Waikanae North Development – Urban Design s53 Response

Project	Waikanae North Development
Application reference	FTAA-2603-1194
Site	169-171 Peka Peka Road, Waikanae, Kapiti Coast
Document	Response to comments received under section 53 of the Fast-track Approvals Act 2024
Prepared by	Matthew Wenden, McIndoe Urban Ltd
Date	10 August 2026
Revision	Final

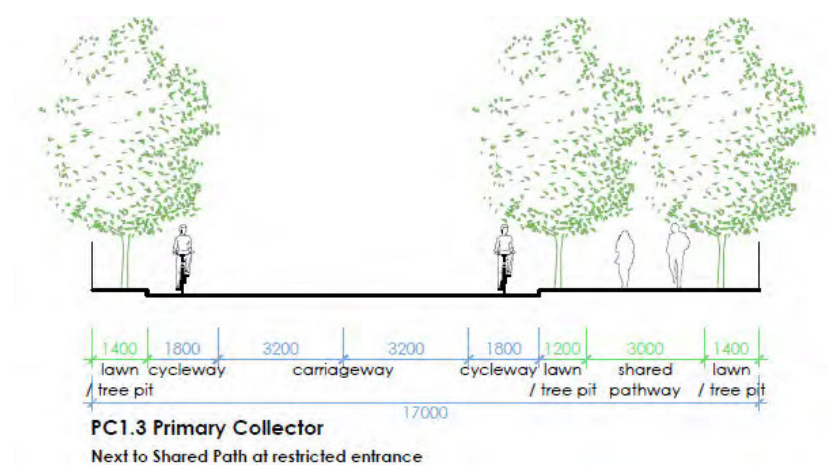
Comment. Several submitters seek clarity on, or express concerns over the timing and traffic impacts of planned access links, specifically requesting that key connections - such as the Ngarara Road extension to Waikanae township - be physically constructed during the initial development phase rather than just deferred or enabled for future build. They highlight a lack of details regarding future integration with surrounding networks like Kensington Drive and broader southern/western links, while warning that inadequate connections will trigger local traffic issues like rat-running through Paetawa Road to the Waikanae Beach interchange.

Urban Design response. The masterplan explicitly establishes the spatial layout and structural provisions required to enable long-term connectivity with the wider network when opportunities arise to achieve these. To integrate with the broader movement network, the design provides specific future link opportunities, including a Secondary Connector Road aligned to a paper road leading toward Ngarara Road to the southwest, as well as three vehicle connections along the northern boundary.

These connections to the north of the site provide the opportunity for a further connection to Peka Peka Road via Kensington Drive, or a future connection to Peka Peka Link Road. These connections are dependent on the future of the surrounding properties and whether these are developed in the future.

These connections safeguard the potential to deliver a connected residential environment if surrounding sites urbanise in the future, while acknowledging that the full realisation of the connection is beyond the scope or control of this application.

Therefore, the proposal does what it can to provide for future connections, within the site that is within the control of WNDL. Future connections have been a key design consideration and the future proofing of those connections is ingrained and provided for. WNDL is however unable to control matters that are outside of its scope – it can only maximise those future opportunities and the design of the proposal has done that.
